Notice of market rule modification

Paper No.	EMC/RCP/13/2004/233
Rule reference:	Gate Closure Reduction
Proposer:	Market Administration (EMC Pte Ltd)
Date received by EMC:	19 April 2004
Category allocated:	2
Status:	Approved by EMA
Effective Date:	1 July 2004
Summary of proposed rules change:

PAPER NO. : **EMC/RCP/13/2004/233**

SUBJECT : **GATE CLOSURE REDUCTION**

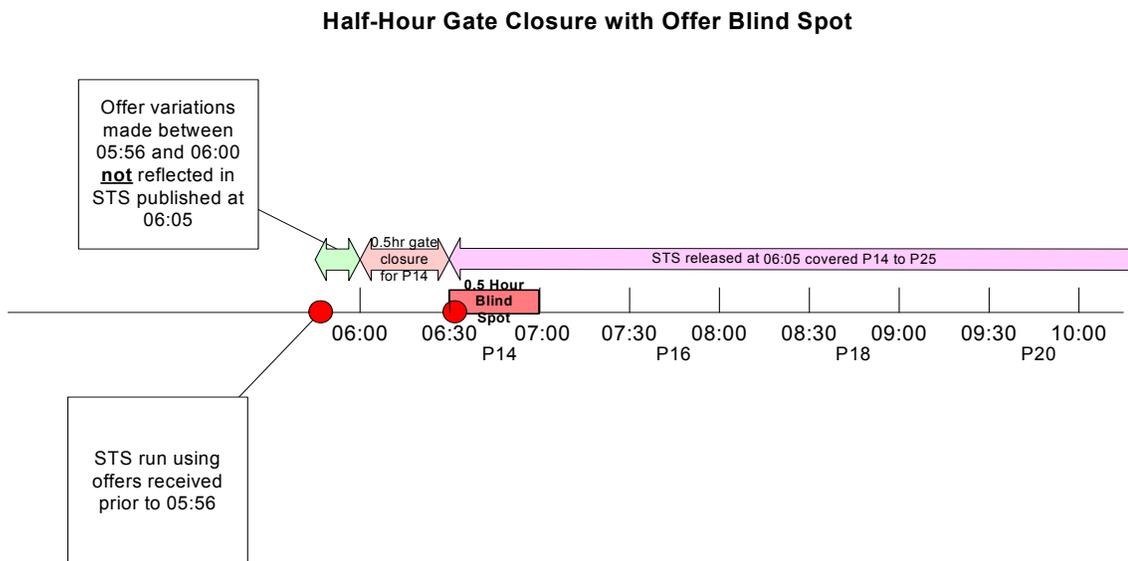
In practice, we need to determine what the shortest possible gate closure period for our market is. In this regard, we think that a half-hour gate closure is infeasible because it will give rise to a 'blind spot', i.e. offer variations made in respect of a dispatch period will not be captured in the STS that is released to MPs or PSO. The diagram below illustrates this:

Currently, the STS runs half-hourly and 4 minutes prior to the start of a dispatch period (i.e. T - 4minutes). Suppose the MCE runs the STS at 05:56.³ If we have a half-hour gate closure, then offer variations made by gencos between 05:56 and 06:00 for P14 (as shown by the green arrow) will not be reflected in the STS released at 06:05. The unseen offer variations thus create a 'blind spot' such that the gencos and PSO would not have up-to-date information (for P14 in this example) required for them to manage the output of plants and the power system effectively.

To avoid the 'blind spot' in the STS, the gate closure has to be at least 34 minutes prior to the commencement of the first dispatch period in the STS that is released to the MPs or PSO. Since our market uses half-hourly period for dispatch, pricing and settlement, it is only natural to apply the same convention for gate closure. Then the shortest possible gate closure period would be 1-hour. As a result, the feasible range of gate closure period is between 1 and 4 hours. To determine the most appropriate gate closure period within this range, we need to further consider two important factors: unit commitment and system security.
